Advanced Molecular Imaging

FSN 88200486

**URGENT - Field Safety Notice
Medical Device Correction
BrightView SPECT, BrightView X and BrightView XCT**

Software Issues identified on the BrightView SPECT, BrightView X and BrightView XCT Systems

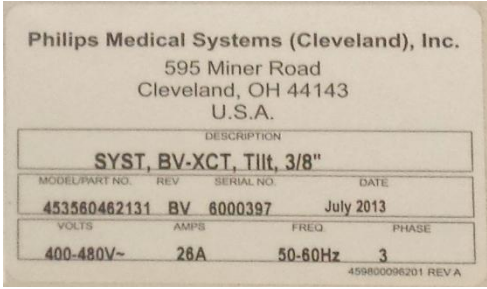
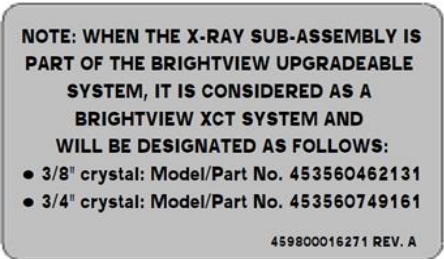
AFFECTED PRODUCTS	<ul style="list-style-type: none"> • BrightView SPECT • BrightView X • BrightView XCT Systems
PROBLEM DESCRIPTION	<p><u>Problem 1:</u> Following a cardiac scan and when using SmartStep* to setup the camera for a Relative 180 procedure, it is possible for Detector 1 to collide with the head holder when moving from the position at which the flat panel is deployed.</p> <p>The issue was not reported by the field but was identified during in-house testing on a BrightView XCT system. This issue only affects BrightView XCT systems.</p> <p>Refer to the “ACTION TO BE TAKEN BY CUSTOMER / USER” section of this Field Safety Notice for additional information in reference to this problem.</p> <p>*SmartStep is the automatic acquisition workflow of the JETStream acquisition station to assist in camera setup and positioning.</p> <p><u>Problem 2:</u> During a patient SPECT lung acquisition, the clinical scan acquisition protocol commanded the gantry rotation to move from the 45 degree to the 90 degree position. Refer to Figure 1 below. However, in the middle of a clinical scan acquisition, the detector heads moved away from the patient (center of rotation) in an uncommanded motion and subsequently the gantry unexpectedly rotated to the 240 degree position. The movement from 90 degree to the 240 degree may take approximately 7 seconds.</p> <div style="text-align: center;"> <p style="text-align: right;">← Center of Rotation</p> </div> <p>Figure 1: Detector and gantry orientation, viewed facing the front of the gantry.</p>

<p>ACTION TO BE TAKEN BY CUSTOMER / USER</p>	<p>Philips is advising the customers/users to retain a copy of this Field Safety Notice with the equipment Instruction for Use, until further notice.</p> <p>Problem #1: Philips is advising the customer/user to perform the following workaround prior to the implementation of the field safety correction, to avoid contact between the detector and the head holder as describe above in Problem #1:</p> <p>ONLY if the system is positioned in a Relative-90 configuration with one of the detectors below the pallet level and the table in in the patient load position: Follow the sequence of operations prior to performing a study utilizing the head holder:</p> <ul style="list-style-type: none"> - Deploy or store the x-ray panel if necessary; - Run the patient load PPM; - Install the head holder; and - Position the patient on the table and proceed with the study <p>In addition, take the following preventative actions:</p> <ul style="list-style-type: none"> • Monitor the patient during any and all system motions. • Know locations of the multiple E-Stop button(s) to halt all system motion. (Emergency Stop: where the system immediately stops all detector and gantry motions by disconnecting power to the motors that control system motion)
